ADDENDUM NO. 1

for
**STEM LAB ALTERATIONS AND RENOVATIONS AT
CLEARVIEW REGIONAL MIDDLE SCHOOL**
located at 595 Jefferson Road, Mullica Hill, NJ 08062

Issued: October 20, 2023

FVHD PROJECT #5162C

Drawing Number
A102

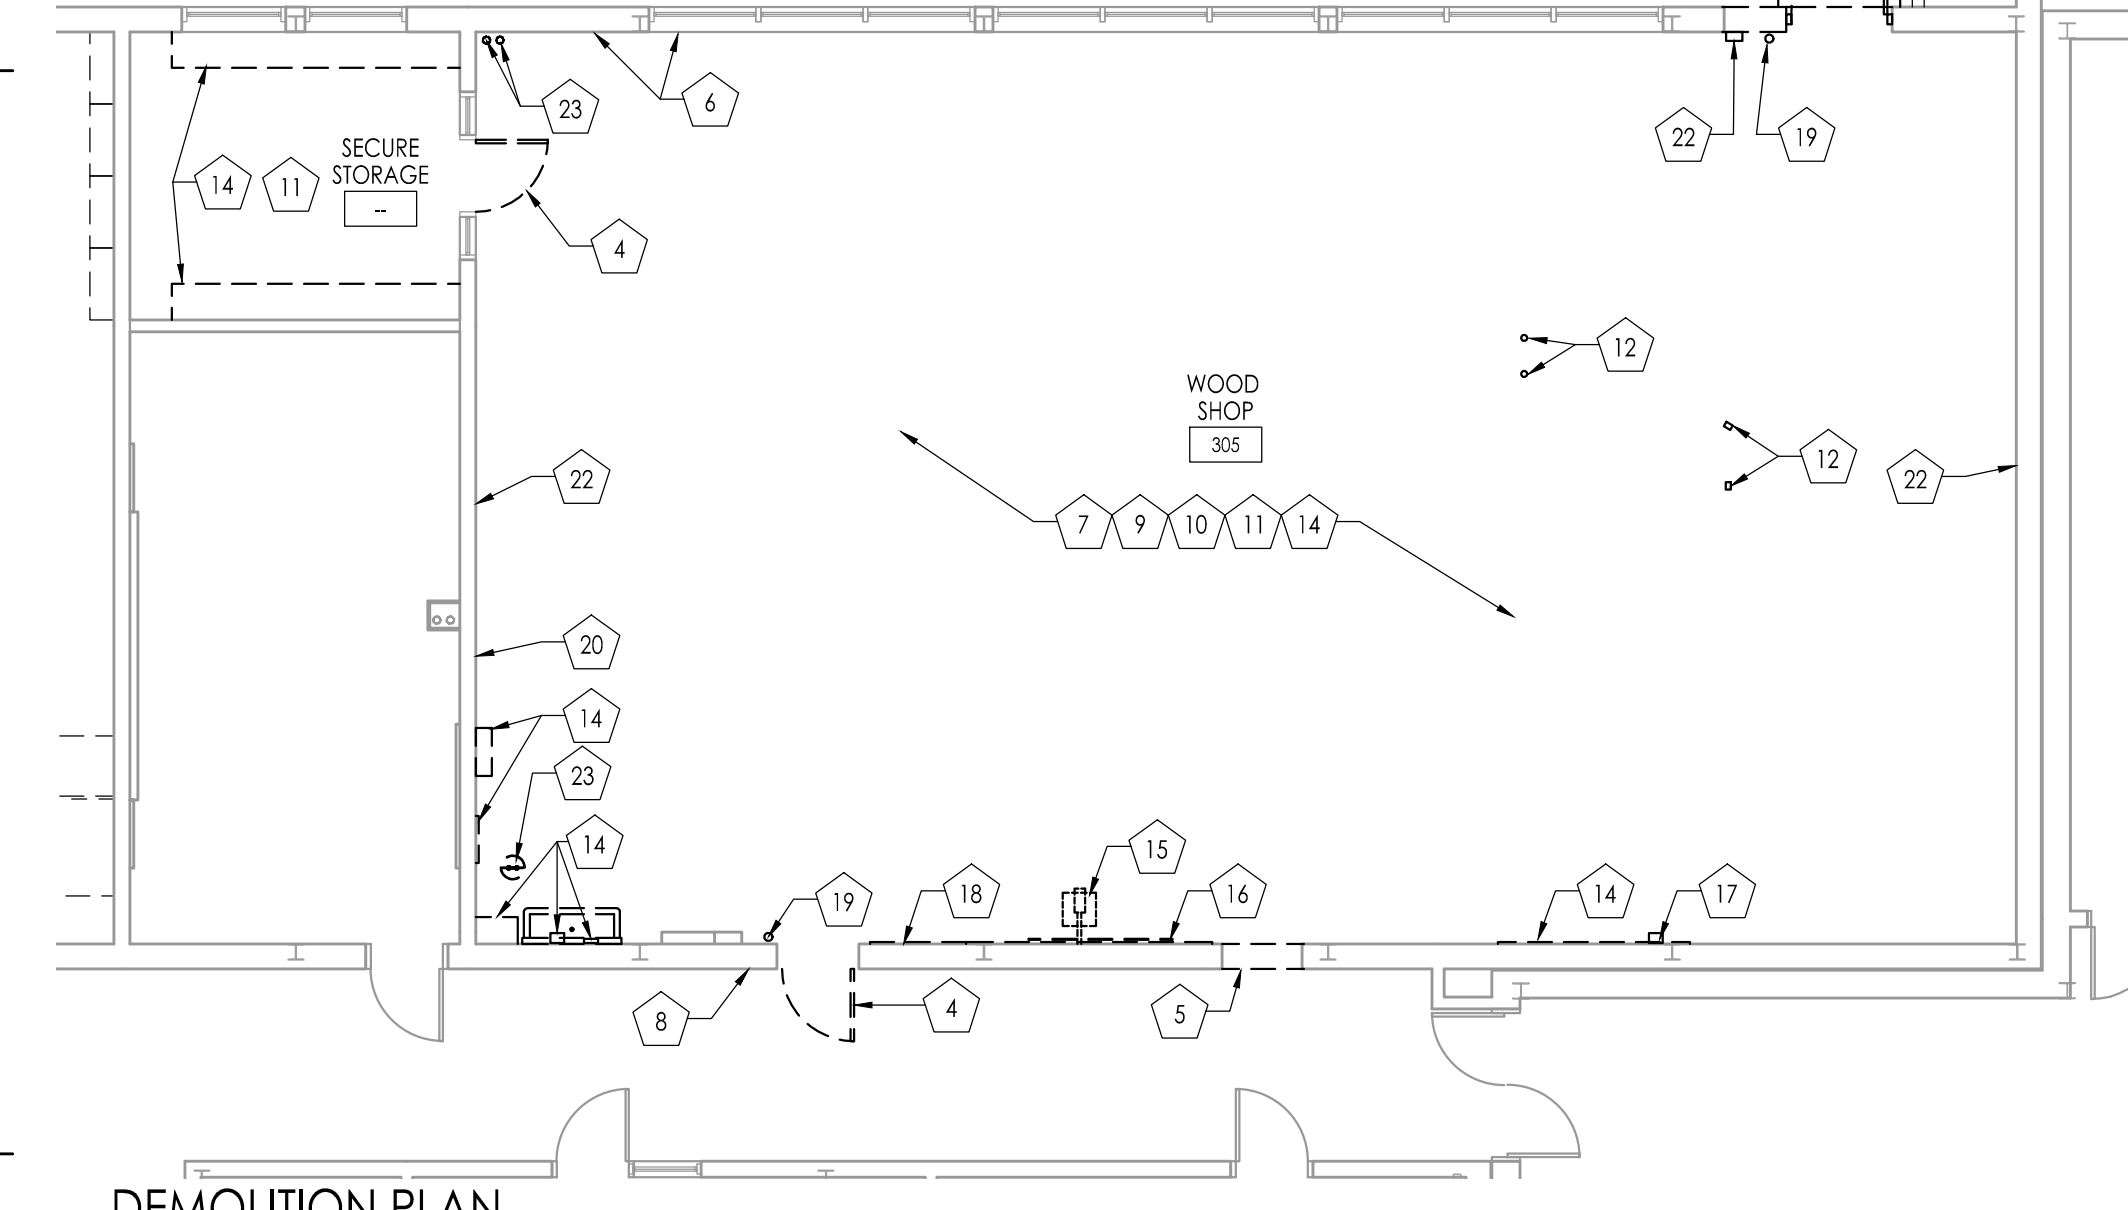
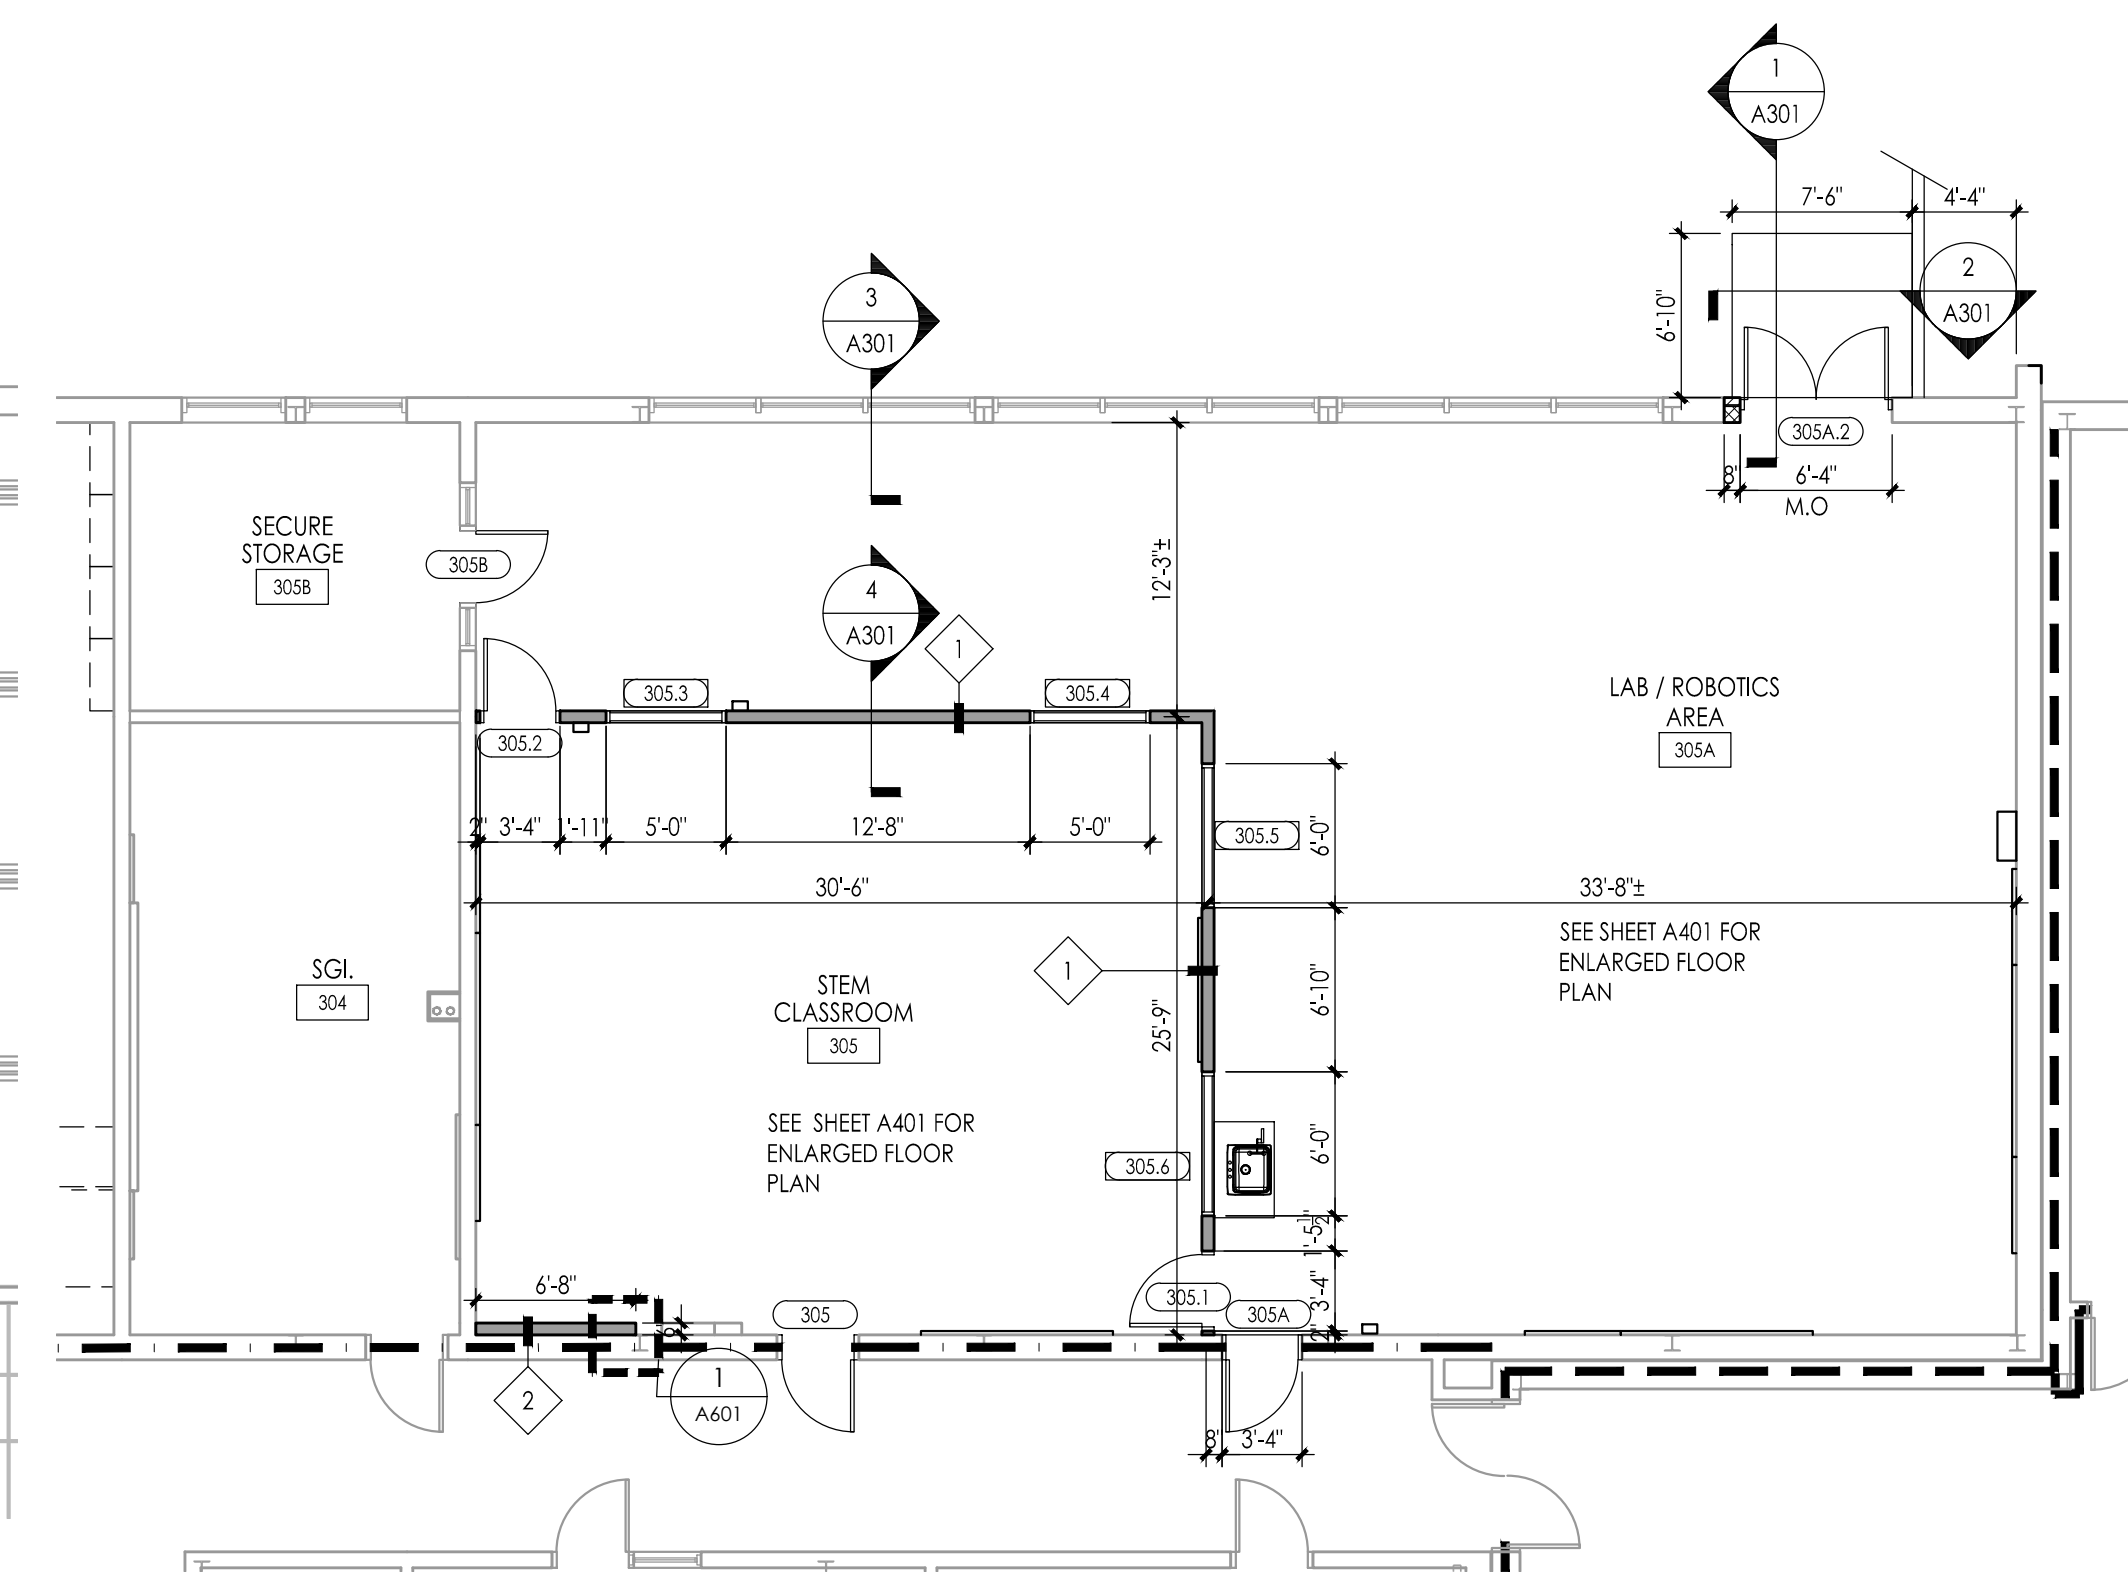
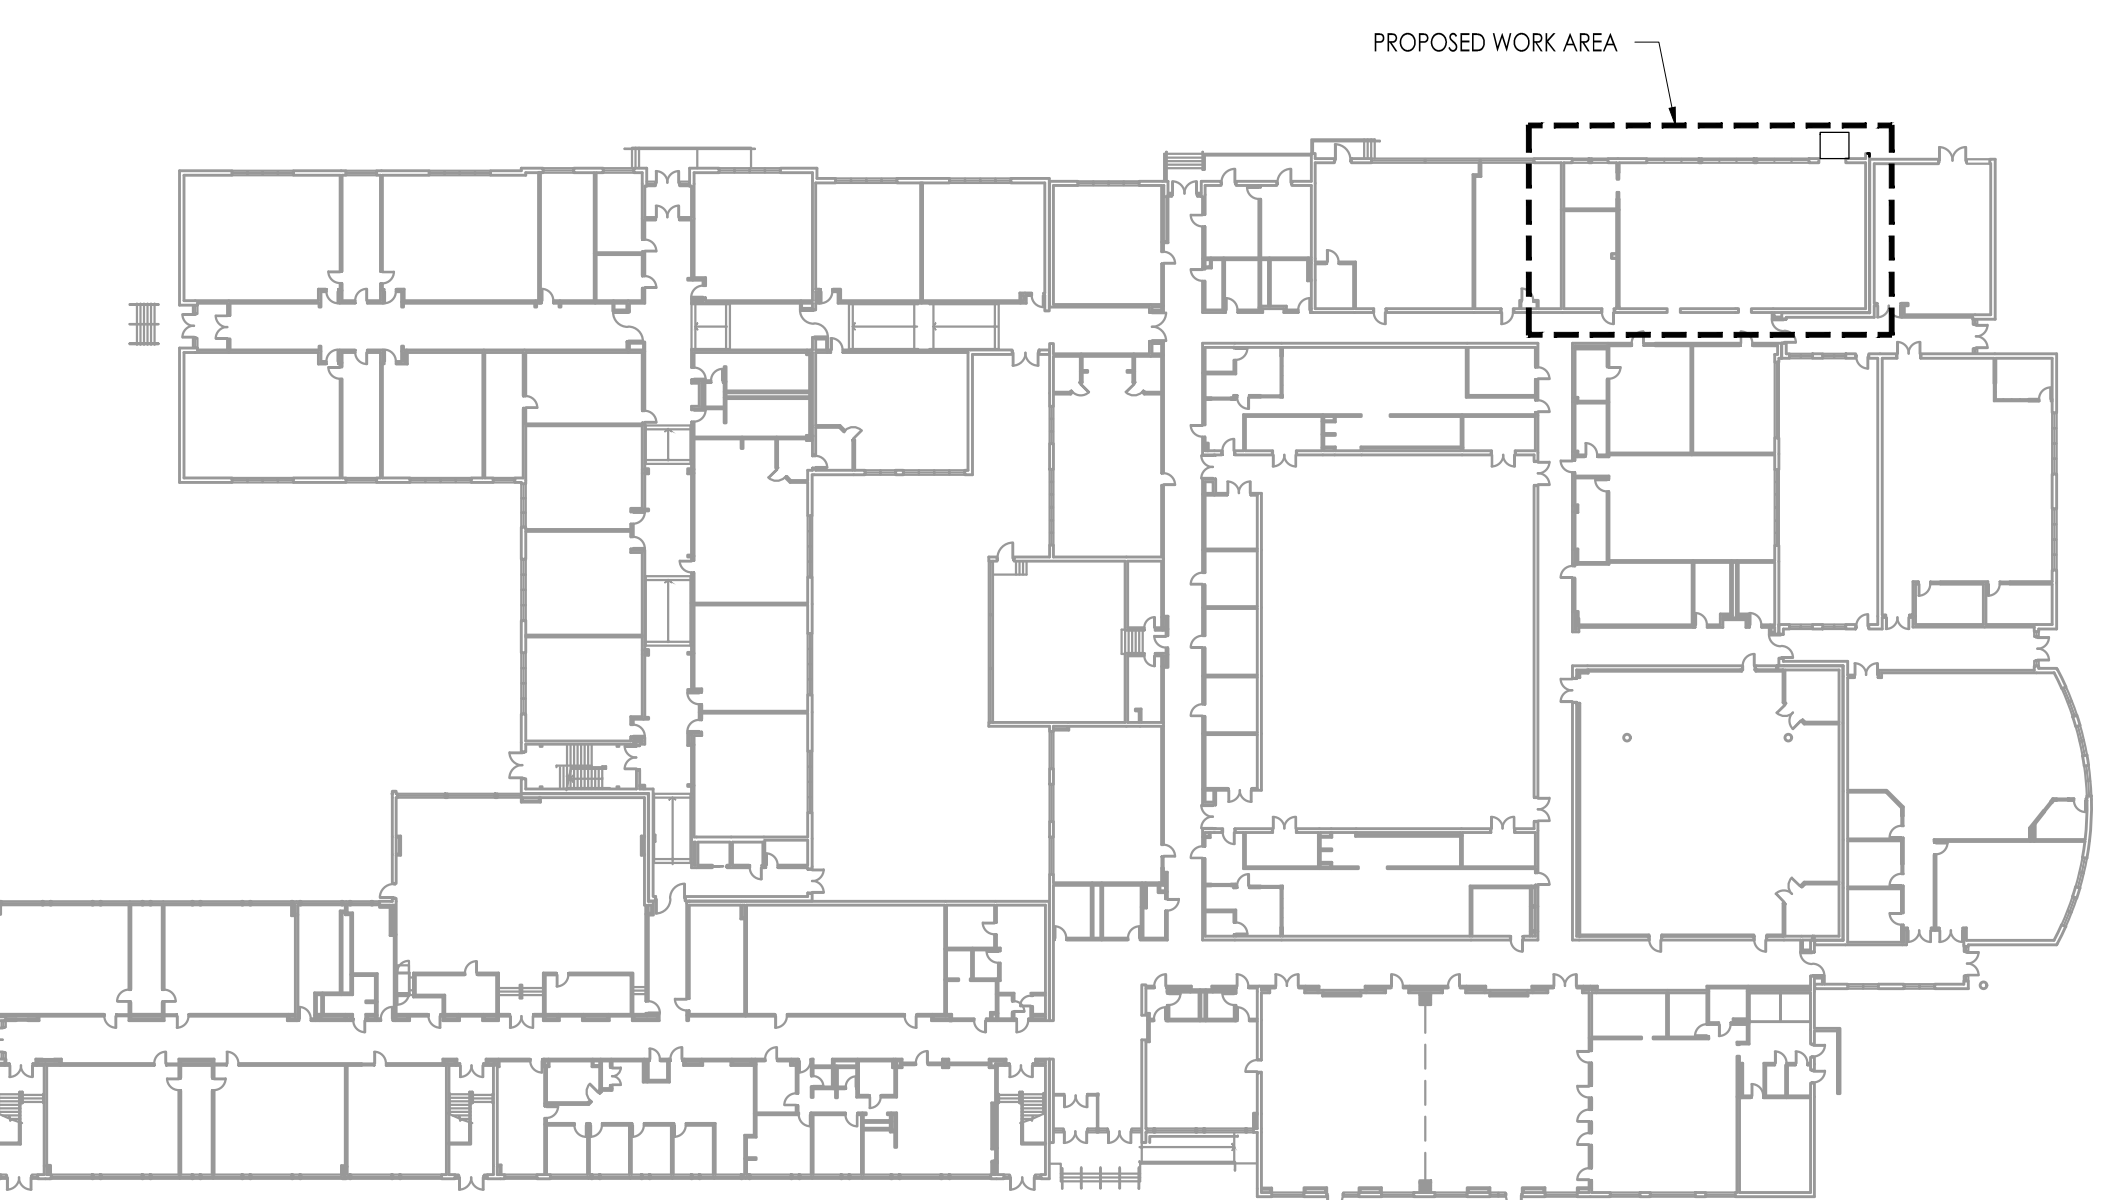
Revisions	No.	Date	Description
	1	10.20.23	ADDENDUM 1
